SUBJECT: Submits response to NRC 990916 telcon RAI re 98-GO-0005,
request for relief from requirements of ASME Boiler &
Pressure Vessel Code,Section XI.

Oconee Nuclear Station - Units 1, 2, & 3
Docket Nos. 50-269, 50-270, and 50-287

Request for Relief from the Requirements of the
ASME Boiler and Pressure Vessel Code, Section XI
Duke Energy Corporation Serial Number 98-GO-0005
Response to NRC Request for Additional Information

EXAMINATION VOLUME FOR STEAM GENERATOR NOZZLE-TO-SAFE END WELDS

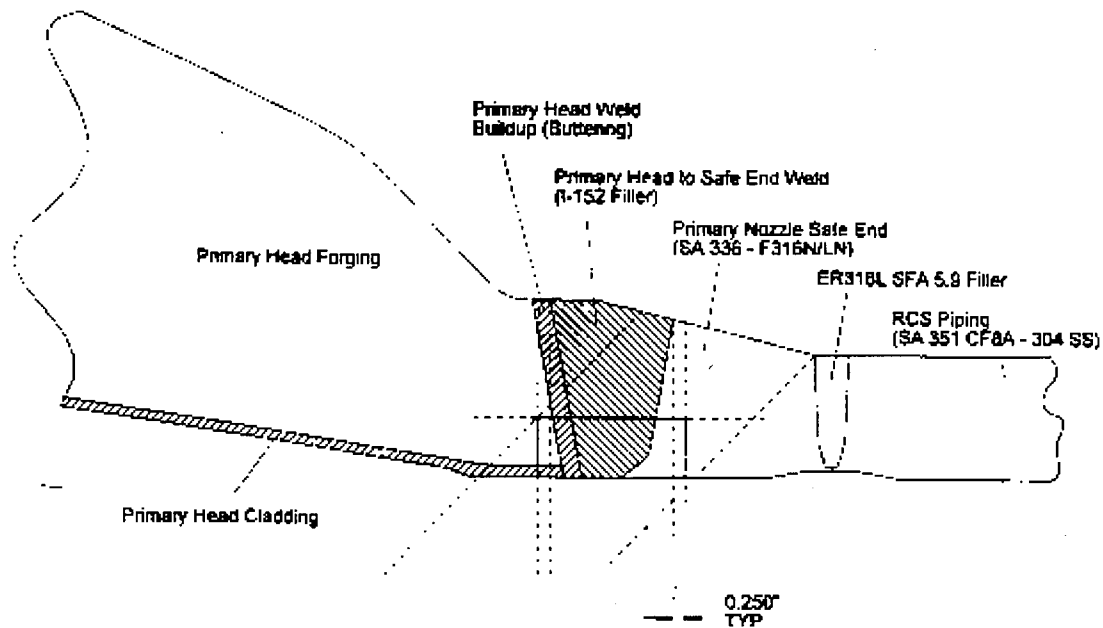
2. In the case of dissimilar metal welds, credit is not taken for single sided coverage. The rules of ASME Section XI, Appendix III, III-4420 are used.
3. Measuring the beam angle in the examination part is not practical when using refracted longitudinal wave search units. However, knowing the beam angle is essential in determining examination volume coverage. The proposed alternative will improve the quality of the examinations by providing a practical method for measuring the beam angle of these search units.
4. As requested by the NRC, dissimilar metal weld configurations are included as the attachment to this letter.
5. This request for relief should have been submitted pursuant to 10CFR50.55a(g)(5)(iii) instead of 10CFR50.55a(a)(3)(iii) as improperly stated in the Duke letter to the NRC dated April 26, 1999.

Axial scan from safe end side only
